RE: **Broadstone Highlands Hotel Block- Springhill Suites  
Central and Mulberry NE  
Grading and Drainage Plan  
Engineer's Stamp Date: 11/28/18  
Hydrology File: K15D034B**

PO Box 1293  
Albuquerque  
NM 87103  
www.cabq.gov  
Based on the submittal received on 11/28/18 the above-referenced Grading and Drainage Plan cannot be approved for Building Permit until the following are corrected:

Re: Broadstone Highlands Hotel Block / Hydrology File K15D034B

Enclosed for your review and comment is a re-submittal of the Highlands Hotel Grading & Drainage Plan. Please see the responses to your comments dated 06/27/18 below:

**OVERALL GRADING & DRAINAGE PLAN**

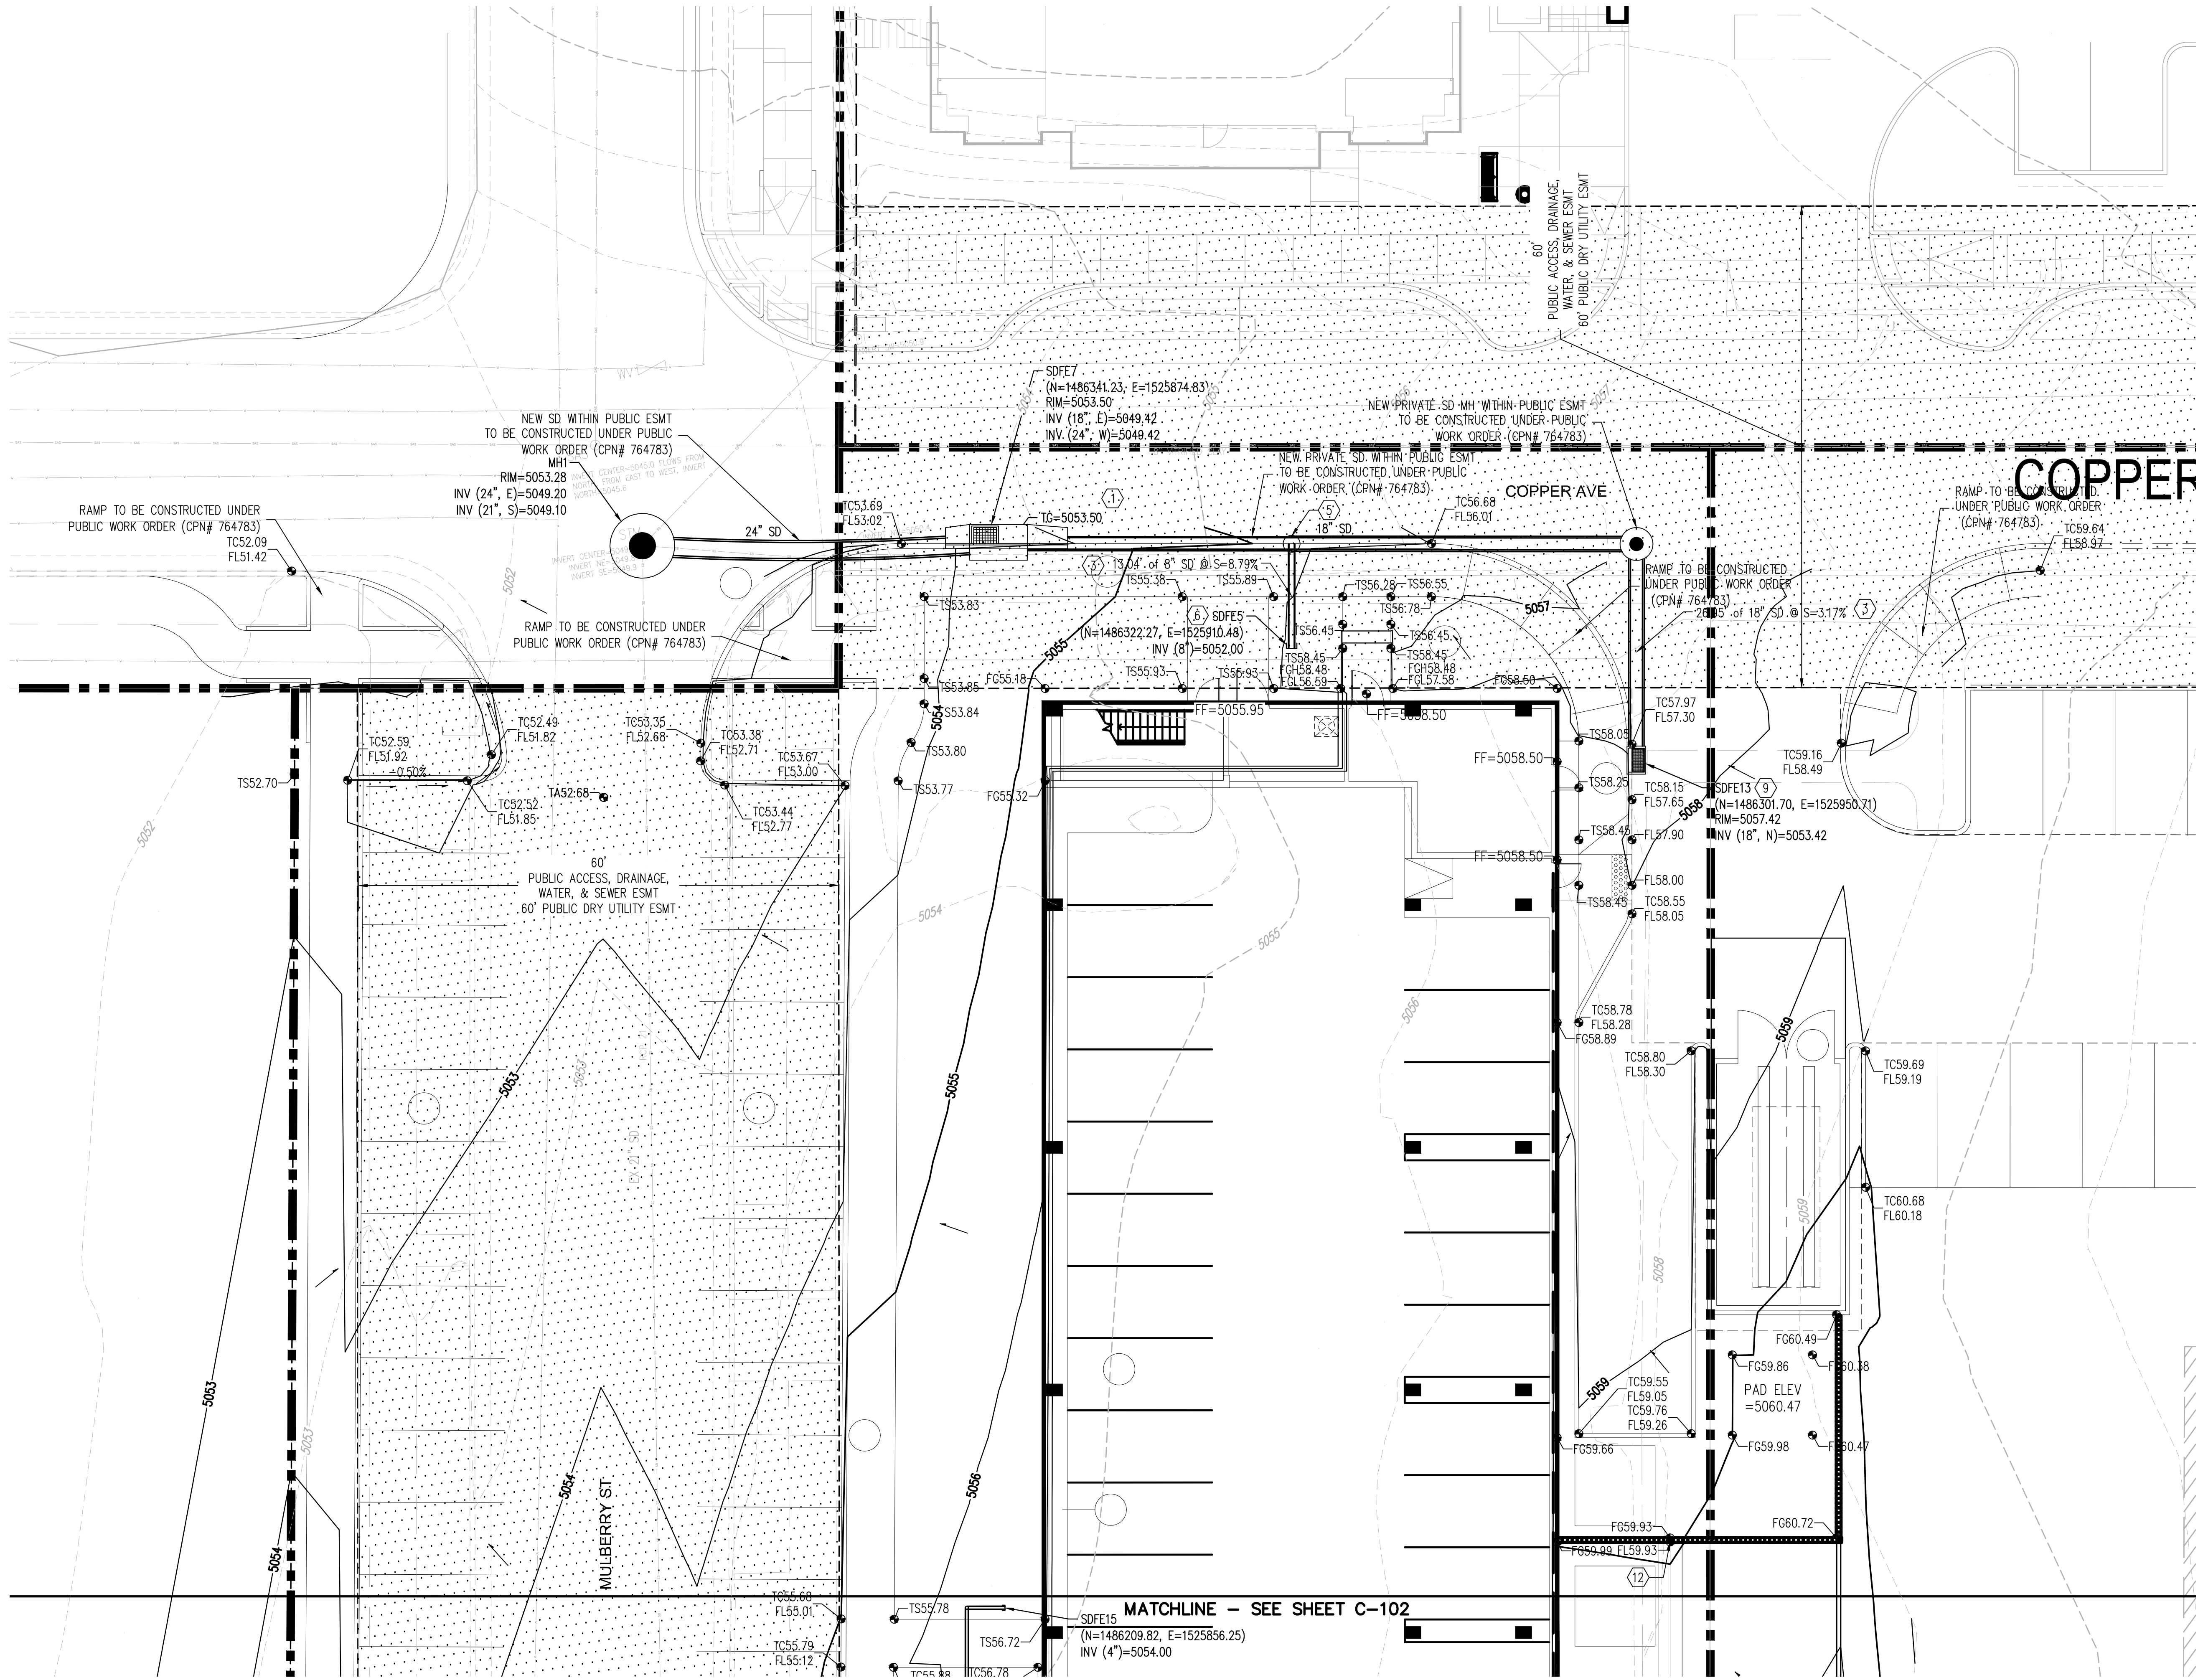
1. This site does not qualify for a Waiver of Management Onsite. There is plenty of room to provide an underground structure far enough away from the building so that settlement will not be an issue. It should be relatively simple to capture nearly the entire stormwater quality volume (SWQV) before it enters the public stormdrain by placing an underground retention pond under vacated Mulberry or using cisterns for the roof runoff. Infiltration trenches can be added in select locations to capture runoff from the remaining paved areas. You are welcome to explain your justification for the Waiver of Management Onsite in more detail, but it will need include identification of either a public or private off-site management pond.

If the waiver requirements are met, then the City will not require Payment-in-Lieu since the site is in the MRA. But if the waiver requirements are not met then the developer will have to manage the SWQV onsite or he will be allowed Payment-in Lieu for any of the SWQV that he chooses to not manage. If requesting Payment-in-Lieu, the plan will need to state that the SWQV can be managed onsite, the owner doesn't wish to manage onsite, and the owner wants Payment-in-Lieu of Management Onsite.

2. If requesting a Waiver of Management Onsite, the following conditions of the new drainage ordinance (enacted 10/2/18) must be demonstrated on the plan (§ 14-5-2-6 (H)):

Show where stormwater quality can be effectively controlled through private offsite mitigation, or through an arrangement to utilize a cooperator's existing regional stormwater management infrastructure or facilities that are available to control stormwater quality.

1. The private encroachment into the Copper public easement by the stem wall footer requires an encroachment agreement....

2. Payment of the fee in lieu for the first flush volume is required.....

*Response: The building was moved slightly to the south to remove the stem wall and footer out of the existing public easement. Drainage basins remained unchanged and the proposed conditions will continue to function as previously reviewed. Since this move was completed, an encroachment agreement is no longer necessary.*

*Response: Due to the infill nature of this project and the high density of the development we originally requested that the first flush requirement would be completed under the payment in lieu option. We understand that under the new Drainage Ordinance dated 9/17/2018, it is noted that this area is waived from the pavement in lieu requirement. Landscape areas are depressed were applicable to account for some onsite ponding*
